# SERVICE BULLETIN REVISION NOTICE

ENGINE — ENGINE BUILD UNIT (EBU) — TERMINAL MODULE ASSEMBLY — REROUTING  
OF THE HARNESS

Turbojet Engine Service Bulletin No. V2500-ENG-71-0275 Revision No. 2 dated June 26, 2015.

# SERVICE BULLETIN

REROUTING OF THE TERMINAL MODULE ASSEMBLY — HARNESS CABLES  
FIGURE 1, SHEET 1 OF 3

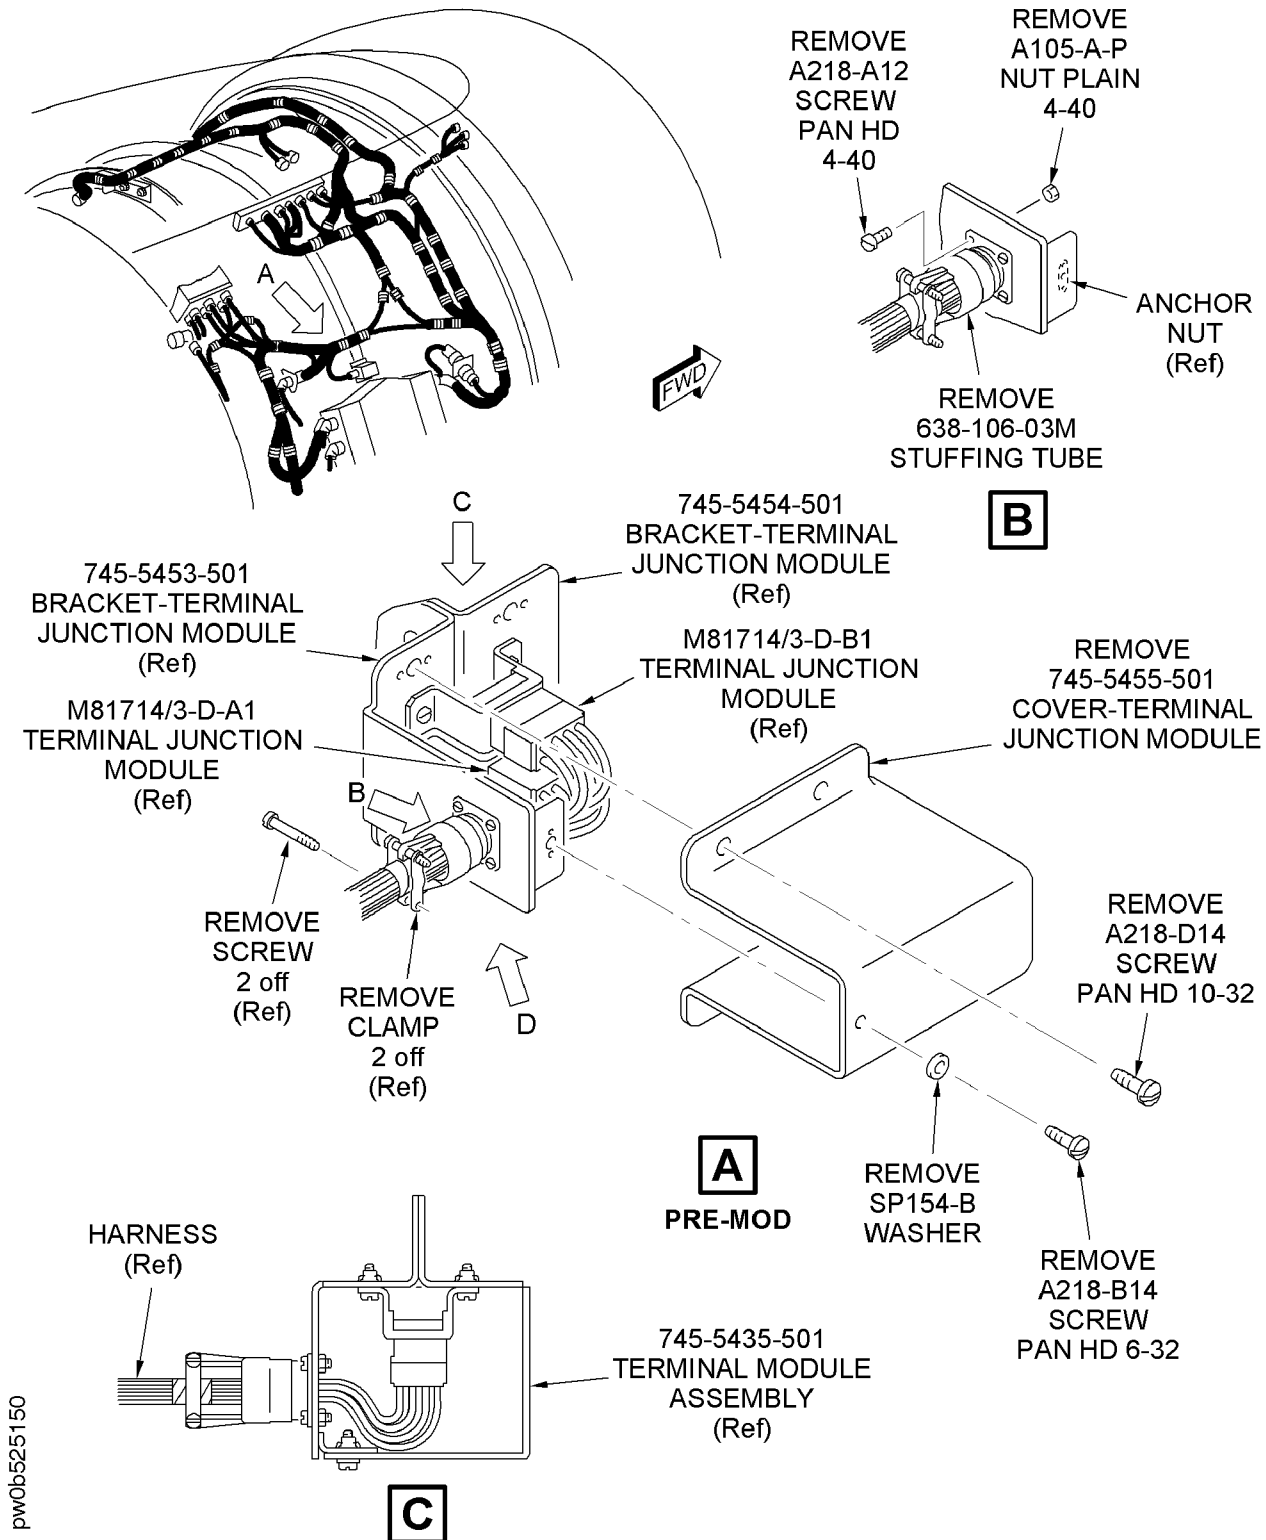
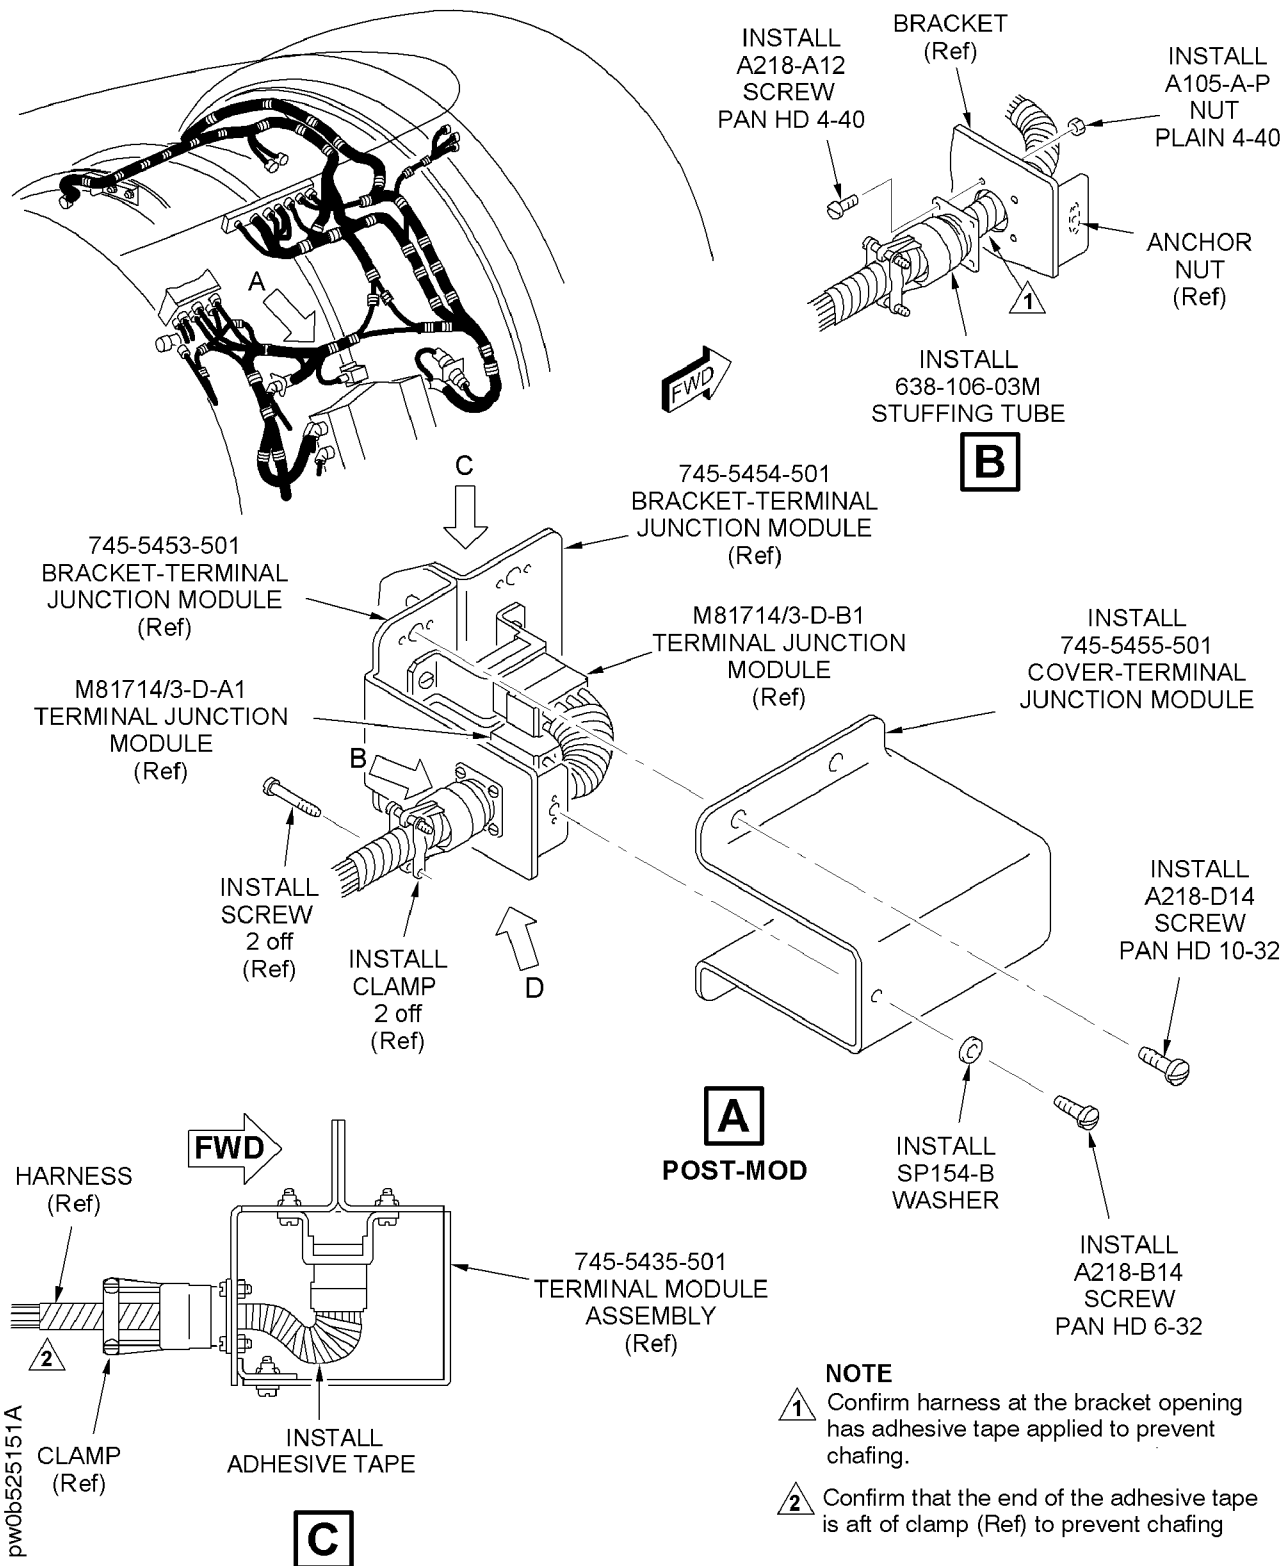
The existing Harness Cables located inside the Terminal Module Assembly are relocated in a different position and further protected with an additional insulating layer

- A. Find the Terminal Module Assembly, PN 745-5435-501 looking forward on the engine, in the two o'clock position, at the termination of the Harness (ref). Refer to Figure 1.
- B. Remove the four Screws — Pan Head 10-32, PN A218-D14 which attach the Cover, PN 745-5455-501 to the Bracket, PN 745-5453-501 and the Bracket, PN 745-5454-501.
- C. Remove the Screw — Pan Head 6-32, PN A218-B14 and Washer, PN SP154-B which attach the Cover, PN 745-5455- 501 to the Bracket, PN 745-5453-501.

- N. Locate the Harness (ref) in the new position making sure that it will not make contact with the Cover, PN 745-5455-501, the Anchor Nut (ref) or the through-hole in the Bracket, PN 745-5453-501.

ADHESIVE TAPE APPLICATION VIEWS  
FIGURE 2, SHEET 1

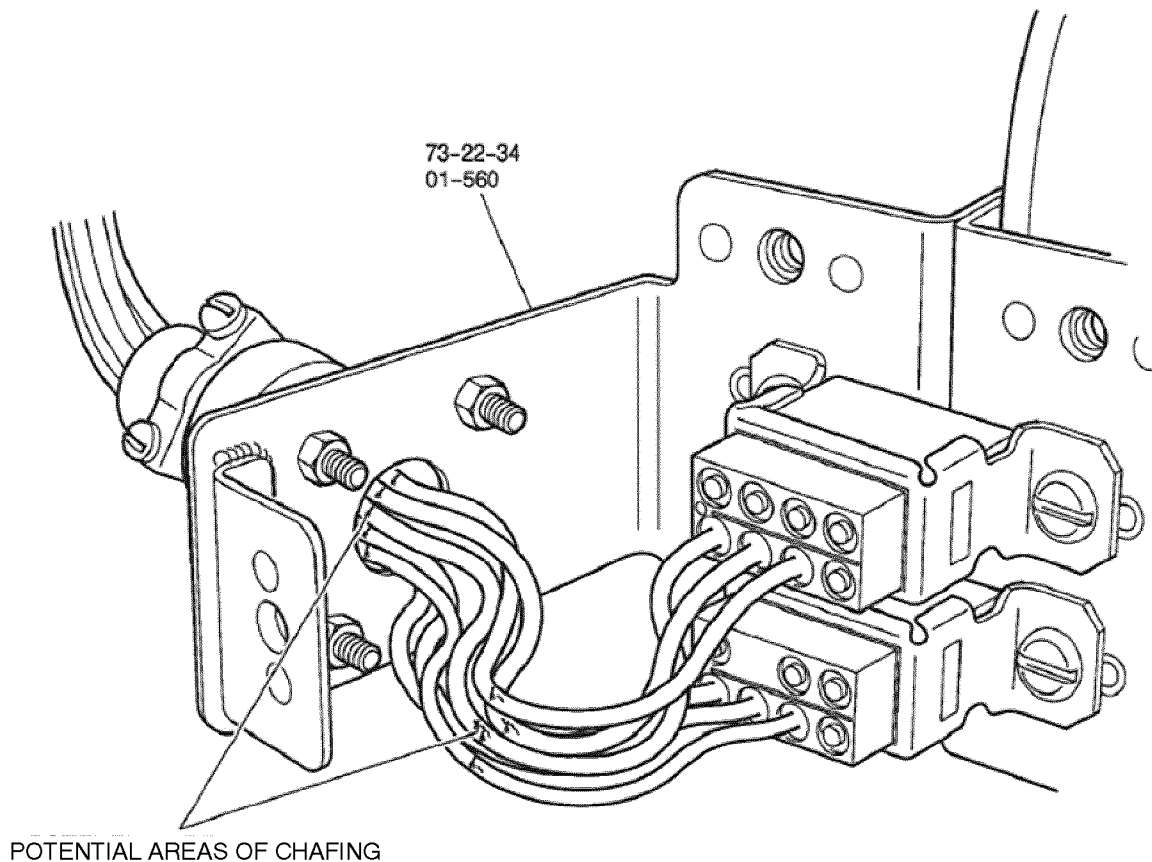
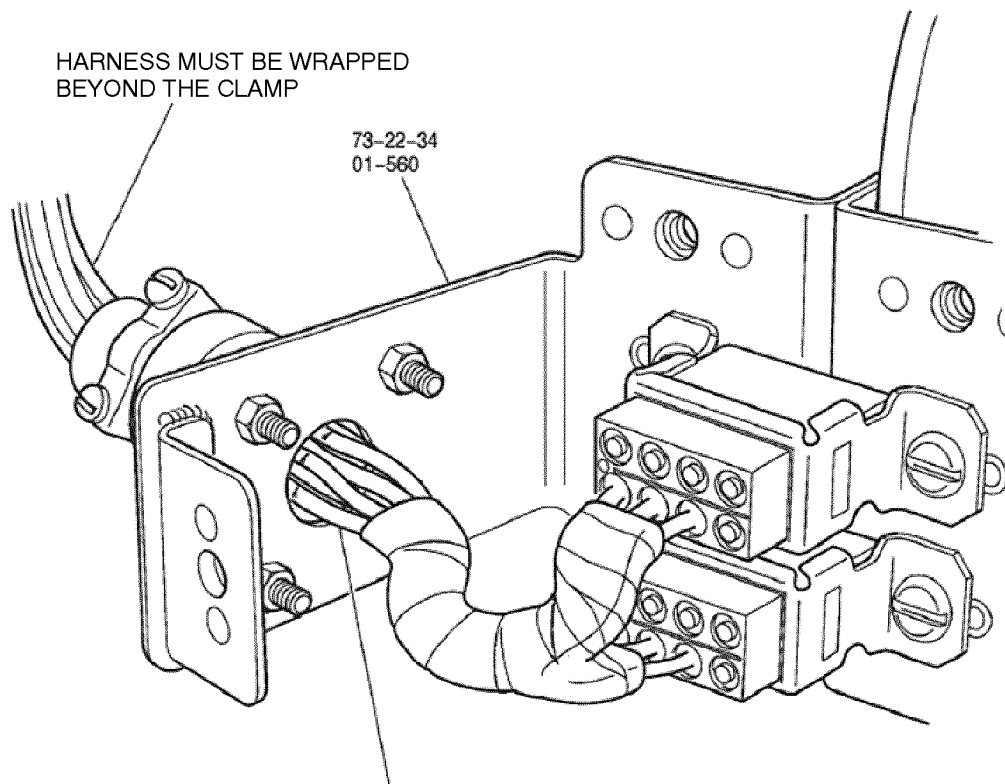
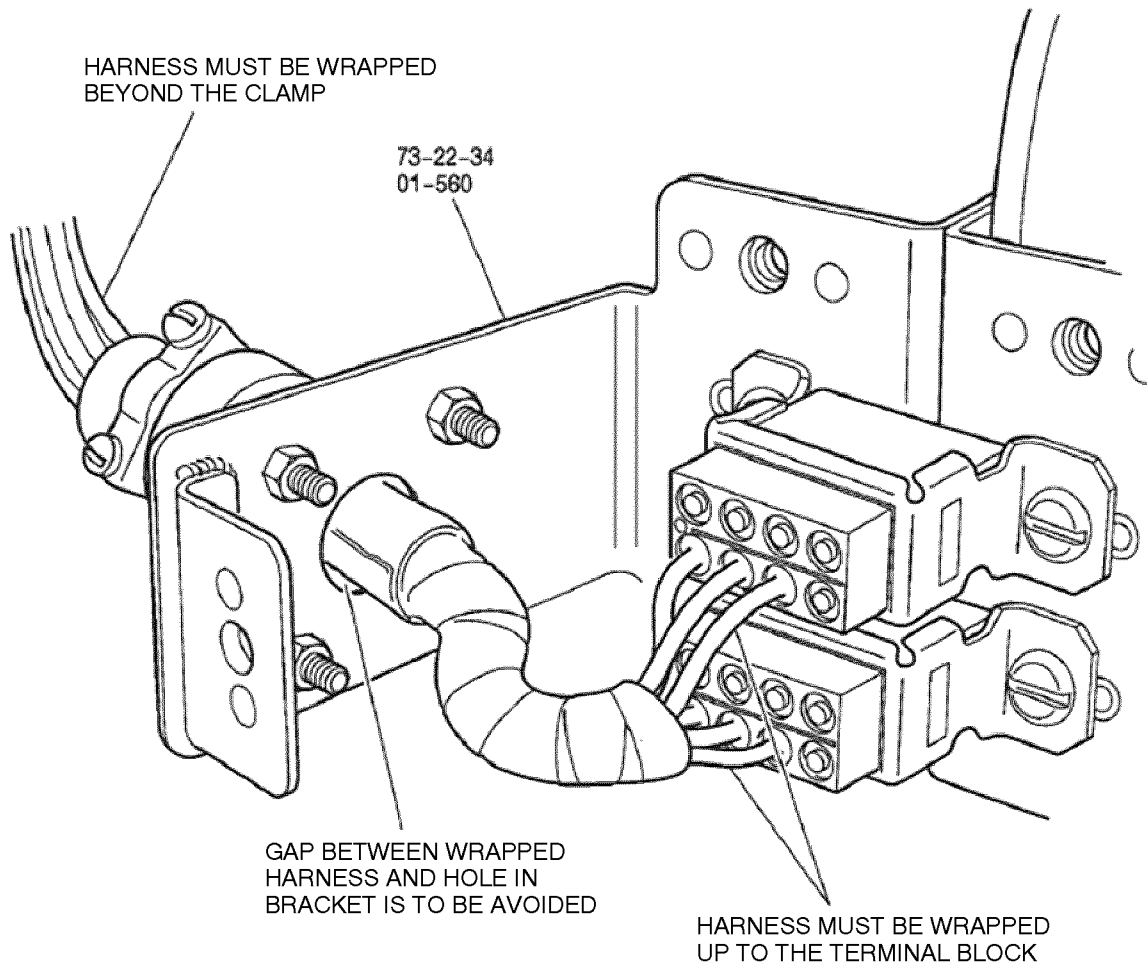
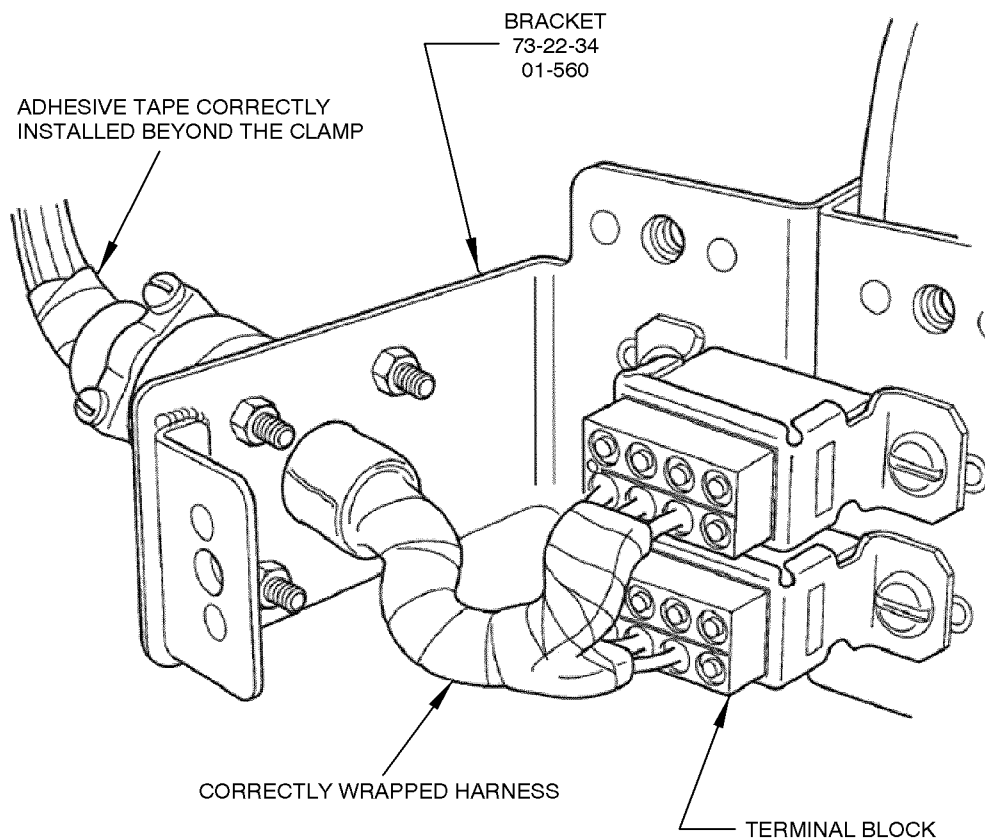
To add Figure 2 to show incorrect and correct views of adhesive tape application.

Some operators did not correctly install the adhesive tape when incorporating this service bulletin. Incorrect installation of the adhesive tape may have caused the harness to chafe. The tape must begin at the terminal block and end beyond the clamp. The total length of wrapping is approximately 6.0 inches (152.4 mm). Several graphics have been added in Figure 2 to show correct and incorrect installation of the adhesive tape. Operators that have previously incorporated this service bulletin must perform an inspection to verify that the adhesive tape was installed correctly. This inspection of the adhesive tape must be completed the next time the engine is at a maintenance base that can do this service bulletin.

- M. Starting from the Terminal Junction Module, PN M81714/3-D-A1 and the Terminal Junction Module, PN M81714/3-D-B1, install three layers of Adhesive Tape (CoMat 02-148) along the length of the Harness (ref) for a distance of approximately 6.0 in. (152.4 mm).

**CAUTION:** TO PREVENT THE HARNESS FROM BEING CHAFED, MAKE SURE THAT THE ADHESIVE TAPE IS APPLIED TO THE HARNESS AT THE BRACKET OPENING. IF THE TAPE IS NOT INSTALLED CORRECTLY, REMOVE THE TAPE AND APPLY AGAIN.

NOTE: Confirm that the end of adhesive tape application is aft of the clamps (ref) .
